## HISTORIC AND DESIGN REVIEW COMMISSION

October 17, 2018

**HDRC CASE NO:** 2018-510  
**ADDRESS:** 118 SWEET  
**LEGAL DESCRIPTION:** NCB 2563 BLK C LOT 6 & E 20 FT OF 5  
**ZONING:** RM-4, HS  
**CITY COUNCIL DIST.:** 1  
**DISTRICT:** Nathan Historic District  
**LANDMARK:** House  
**APPLICANT:** Andreas Wurzer/Andreas Wurzer Construction Inc  
**OWNER:** Sergio & Naema Vides  
**TYPE OF WORK:** Construction of a two story, rear accessory structure  
**APPLICATION RECEIVED:** September 28, 2018  
**60-DAY REVIEW:** November 27, 2018  
**REQUEST:**

The applicant is requesting a Certificate of Appropriateness for approval to construct a two story, rear accessory structure at 118 Sweet.

1951 SANBORN MAP

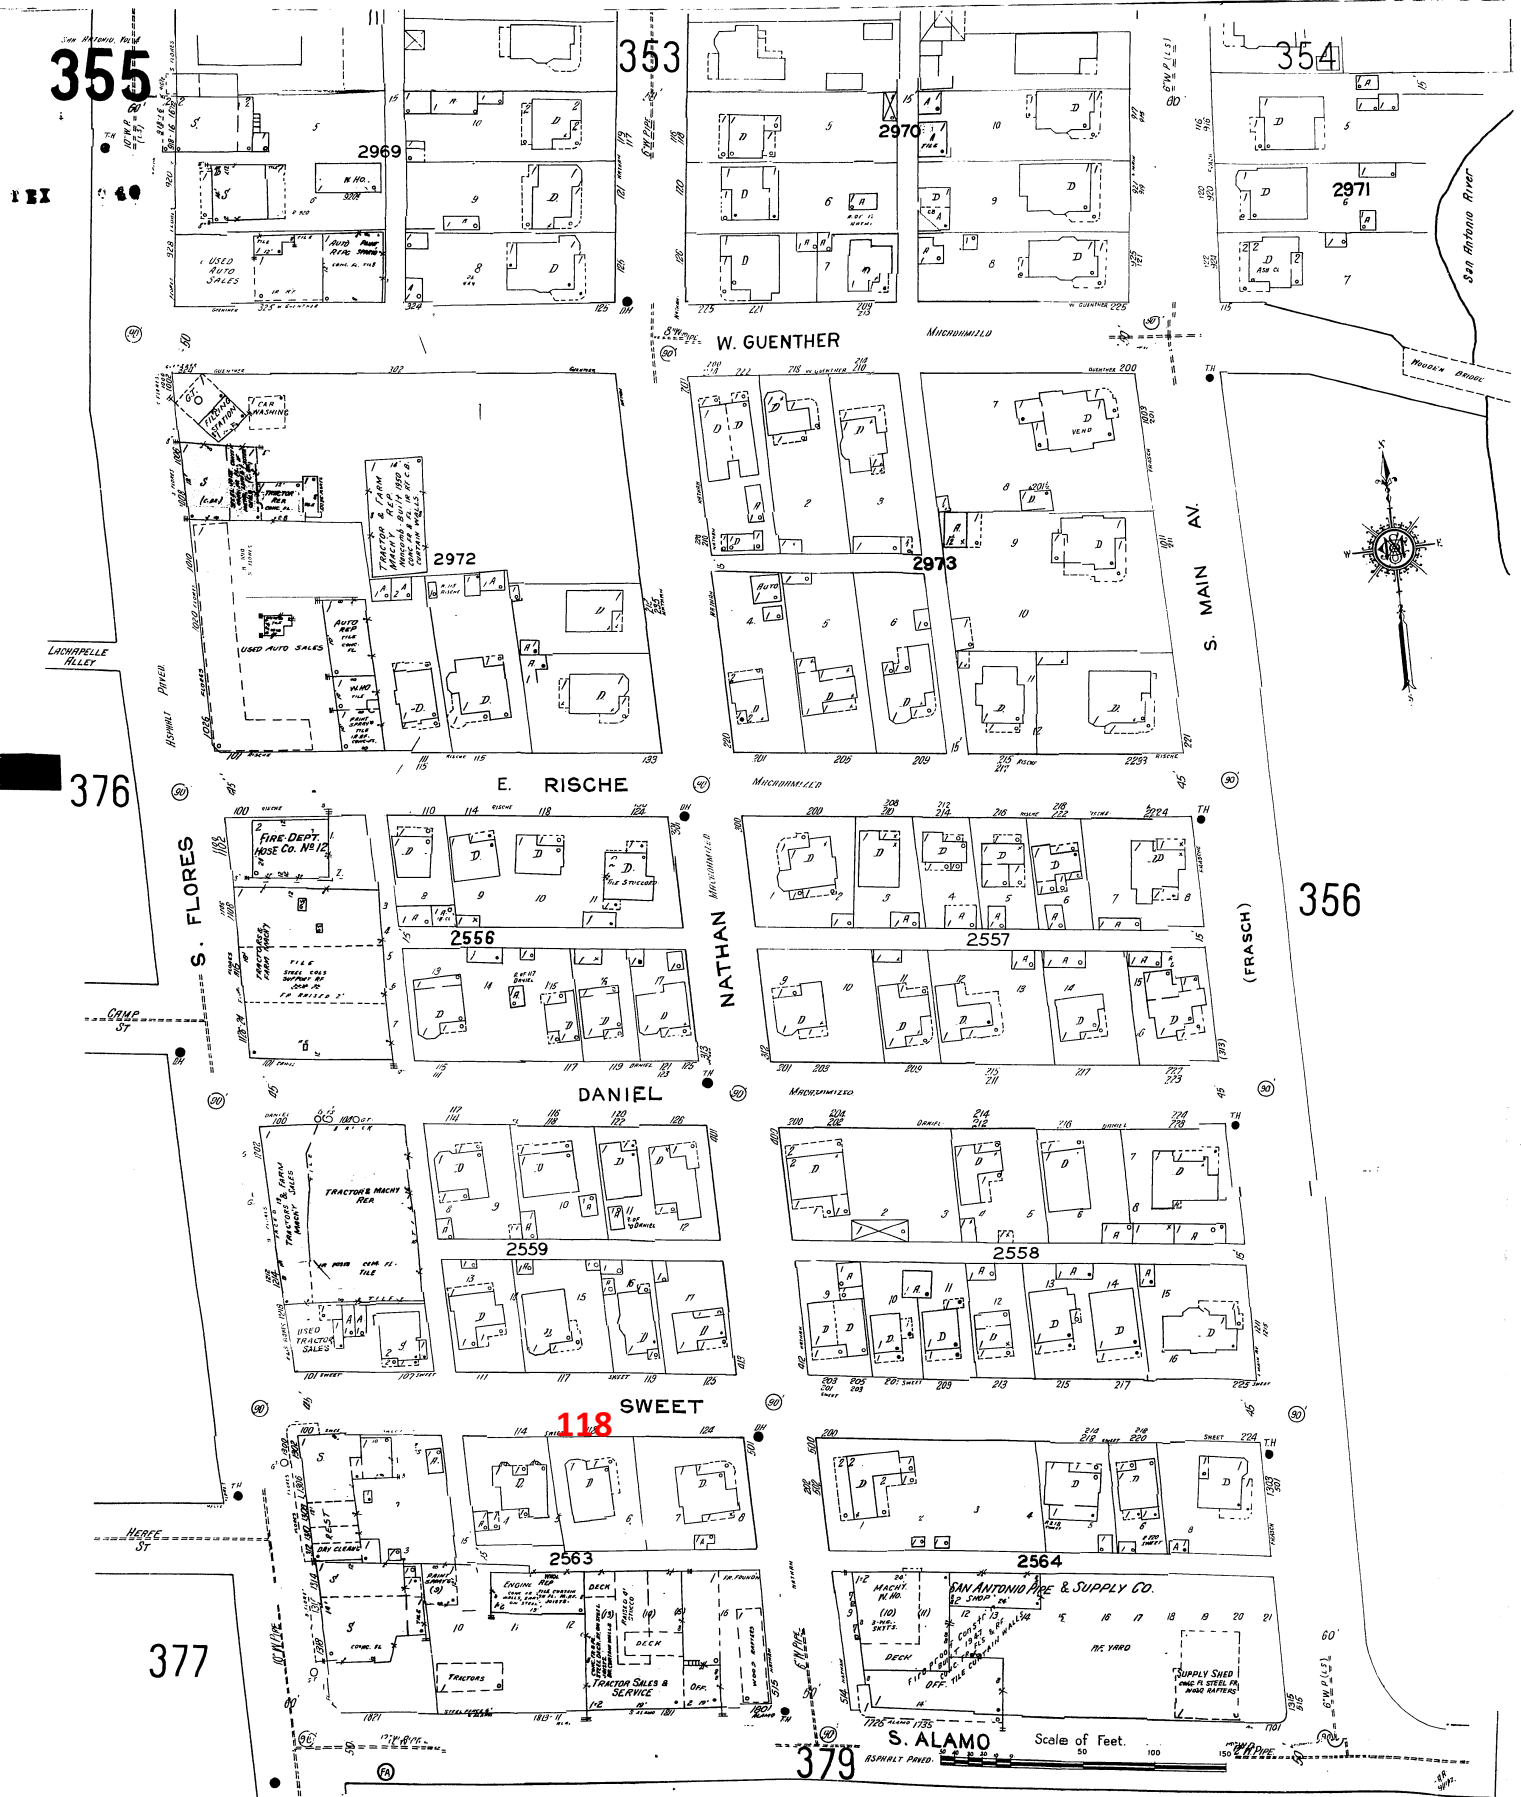
- a. The applicant is requesting a Certificate of Appropriateness for approval to construct a two story, rear accessory structure at 118 Sweet. The applicant has noted that the proposed accessory structure will be constructed in place of an existing, rear accessory structure, which will be removed. The existing rear accessory structure features non-historic elements such as gable return boxes and a contemporary window size. This structure does not appear on the 1951 Sanborn Map.
